SUBJECT: BROWNS FERRY NUCLEAR PLANT, UNITS 1,2 AND 3 - STAFF ASSESSMENT OF INFORMATION PROVIDED PURSUANT TO TITLE 10 OF THE *CODE OF FEDERAL REGULATIONS* PART 50, SECTION 50.54(f), SEISMIC HAZARD REEVALUATIONS FOR RECOMMENDATION 2.1 OF THE NEAR-TERM TASK FORCE REVIEW OF INSIGHTS FROM THE FUKUSHIMA DAI-ICHI ACCIDENT (TAC NOS. MF3764, MF3765 AND MF3766)

STAFF ASSESSMENT BY THE OFFICE OF NUCLEAR REACTOR REGULATION

RELATED TO SEISMIC HAZARD AND SCREENING REPORT

BROWNS FERRY NUCLEAR PLANT, UNITS 1, 2, AND 3

Figure 3.3-1 Plot of Staff's and Licensee's Base Case Shear-Wave Velocity Profiles for the BFNP site

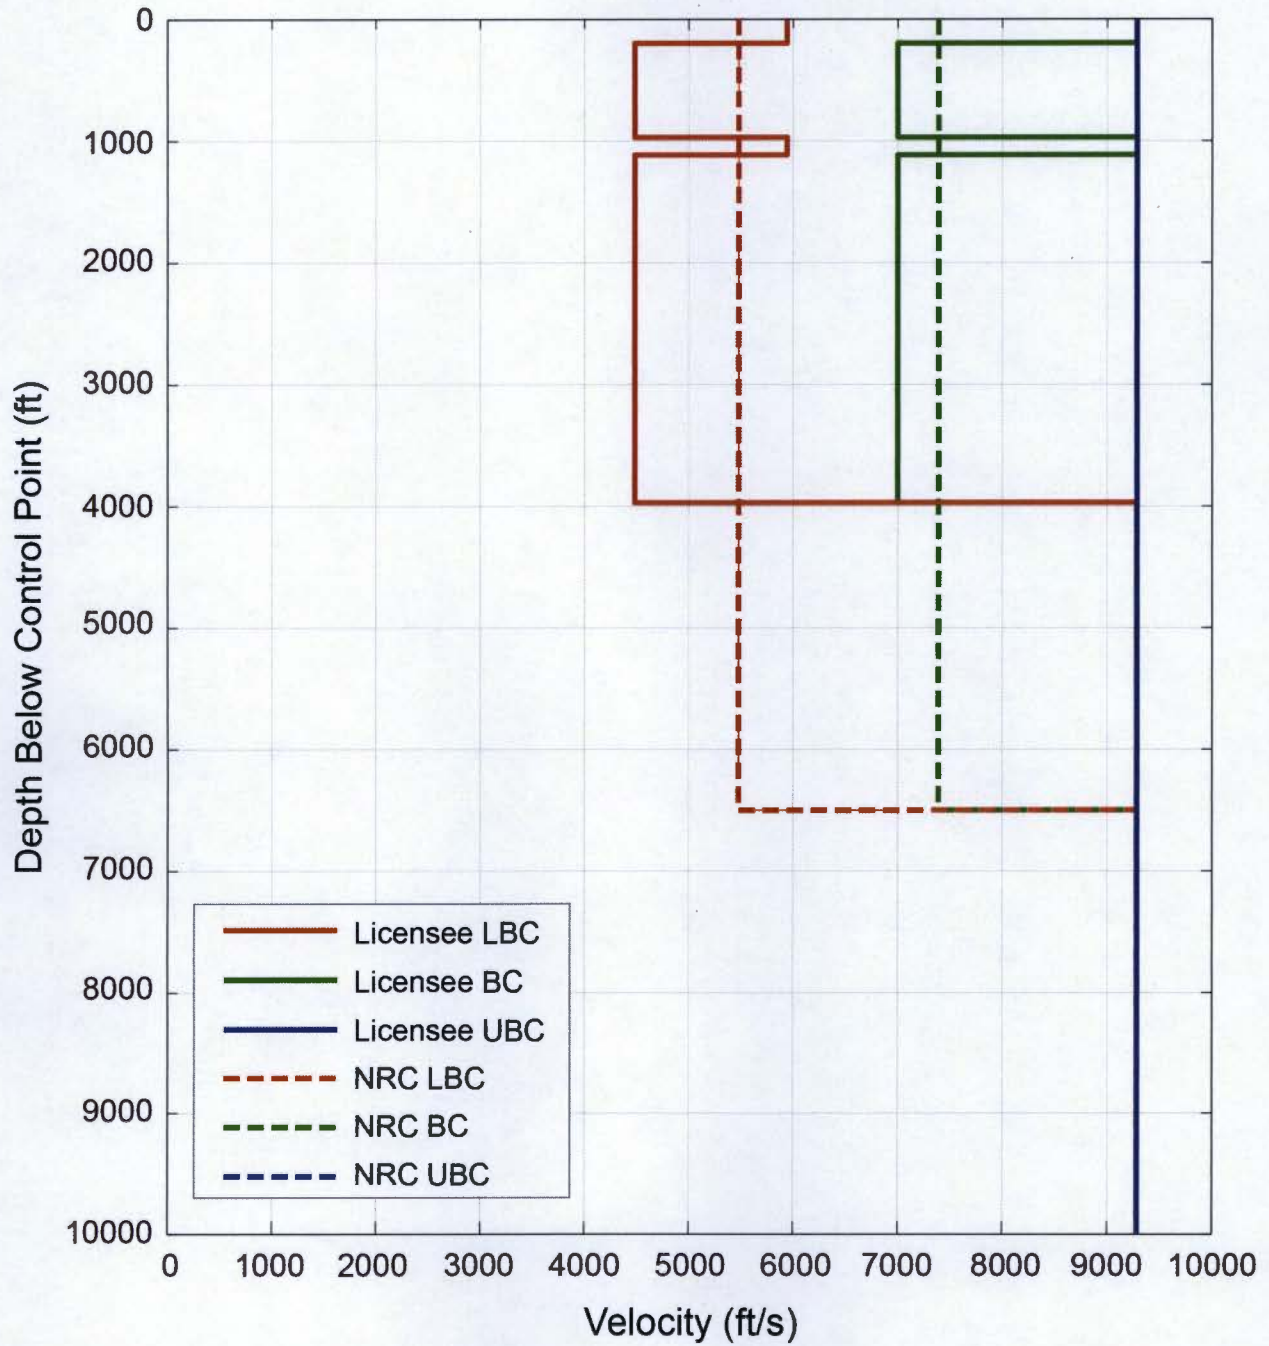
The NRC staff developed three velocity profiles based on the geological information in UFSAR (TVA, Amendment 25.3). Core information from 29 holes drilled in the main plant area places the bedrock at about 50 ft [15 m] below the ground surface. The bedrock below the control point is limestone of Mississippian age Fort Payne Formation. The staff used laboratory measurements of limestone shear-wave velocity reported in Mavko et al. (2009) as well as the velocity profiles in EPRI (2008) to develop its three base case profiles. The measured shear wave velocity for limestone (Mavko et al., 2009) ranges between 5,479 ft/s [1,670 m/s] and 9,974 ft/s [3,040 m/s]. Assuming that this range represents 10 percent and 90 percent fractiles in a log-normal distribution, NRC staff estimated the median shear wave velocity of 7,392 ft/s [2,253 m/s] for the best estimate profile. To develop the upper and lower profiles, the staff assumed a standard deviation of 0.23, which is consistent with the guidance in the SPID. The NRC staff placed the reference or base rock boundary at a depth of 6,562 ft [2,000 m] below the control point (EPRI, 2008). Figure 3.3-1 of this assessment shows a comparison between the staff's and the licensee's base case profiles. The staff's best estimate base-case profile is similar to that of the licensee; however, the licensee's upper and lower profiles are wider, which reflects the licensee's use of a higher standard deviation (0.35) than that used by the staff (0.23).

Figure 3.3- 1 Plot Comparing the Staff's and the Licensee's Median Amplification Functions and Uncertainties for the BFNP site

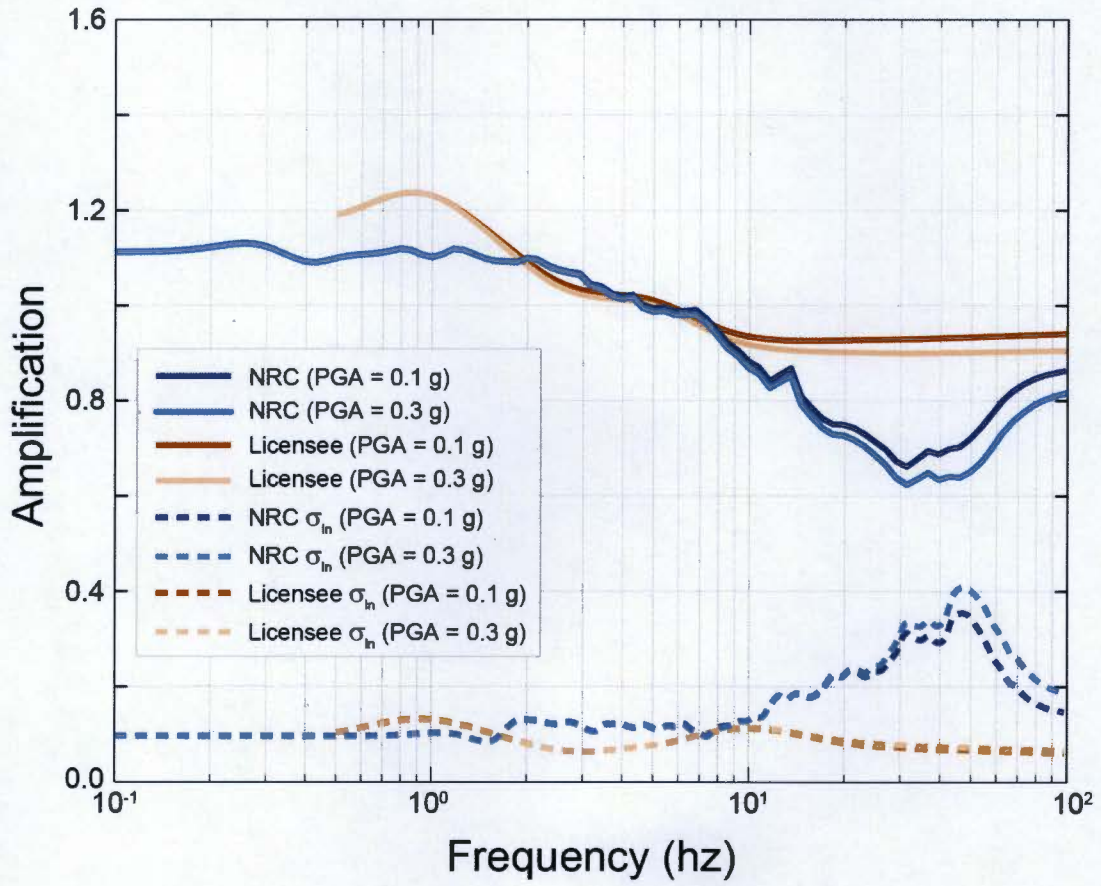
Figure 3.3-2 of this assessment shows a comparison of the staff and the licensee median site amplification functions and uncertainties for two of the eleven input loading levels. As shown in this figure, the licensee's amplification functions are slightly higher at frequencies below 2 Hz, and above 8 Hz. The standard deviations of the licensee are almost identical to those of NRC below 10 Hz, but lower at frequencies above 10 Hz. The differences in the amplification functions are mainly due to differences in the velocity profiles of the staff and the licensee; however, these small differences are within the limits of the uncertainty, and judged by staff to be reasonable.

Figure 3.4-1 Comparison of the Staff's GMRS, Licensee's GMRS, and the SSE for the BFNP site

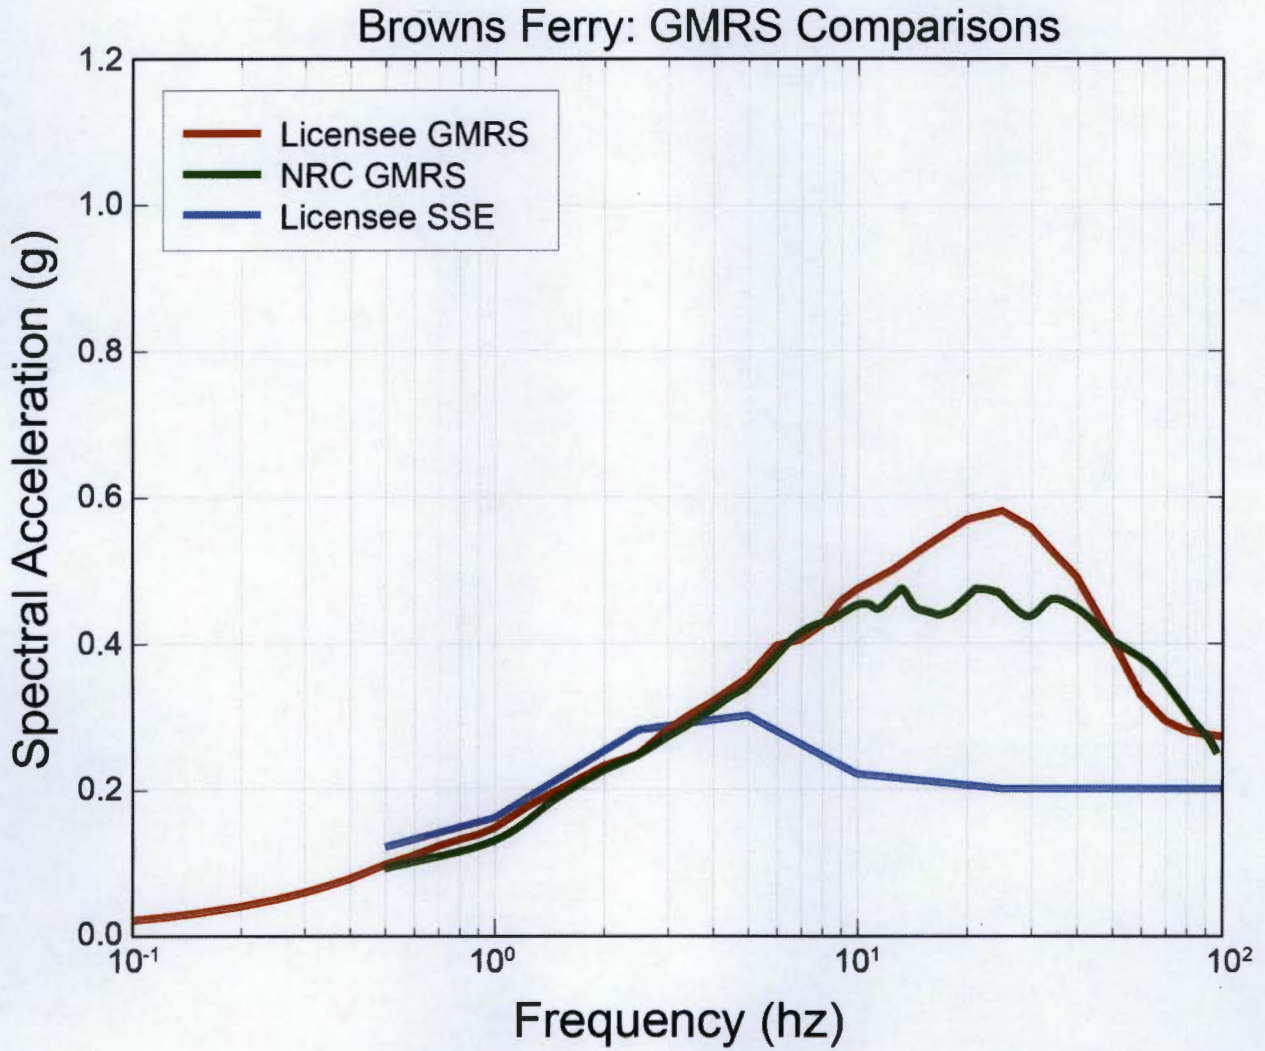
The staff independently calculated the 10^{-4} and 10^{-5} UHRS using the results of its confirmatory PSHA and site response analyses, as described in Sections 3.2 and 3.3 of this staff assessment, respectively. Figure 3.4-1 of this assessment shows a comparison of the GMRS determined by the licensee to that determined by the staff.

As shown in Figure 3.4-1, the licensee's GMRS shape is generally similar to that calculated by the staff at frequencies less than 10 Hz. However, NRC staff's confirmatory GMRS is somewhat lower than the licensee's at frequencies above 10 Hz. As described in Section 3.3 of this assessment, the staff concludes that these minor differences over the higher frequency range are primarily due to the differences in velocity profiles as part of the site response analyses performed by the licensee and staff. The staff concludes that these minor differences are acceptable for this application because the licensee followed the guidance provided in the SPID with respect to both the PSHA and site response analysis for the BFNP site.
